SCOPING OPINION:

Proposed South East Strategic Reservoir Option (SESRO)

Case Reference: WA010005

08 October 2024

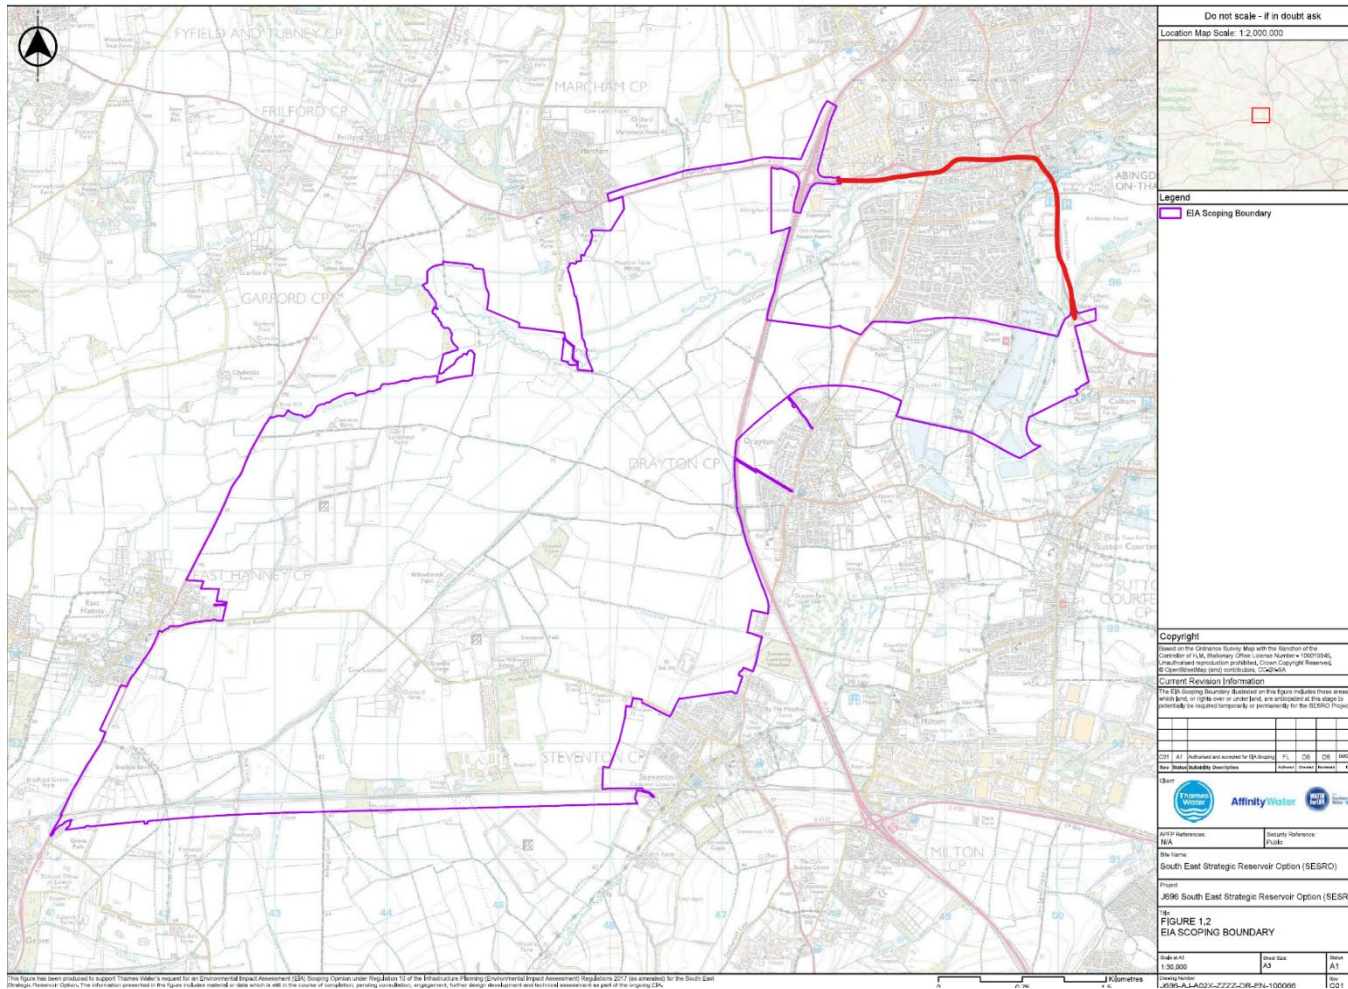
Abingdon Town Council has an issue with these boundaries as they the areas of south Abingdon, in particular the River Ock floodplain from the A34 culvert, continuing in close proximity or through residential areas that have in the past been affected by flooding, to the confluence of the Ock and the Thames.

In the Council’s opinion this area should be scoped into the assessments as the S19 Flood Incident Report referred to in point 4 occurred within that area and we have concerns that SESRO will cause additional water course and groundwater flooding in this well-populated area.

Our scoping would follow Marcham Road, Ock Street and the High Street to the North and Bridge Street to the East as shown:
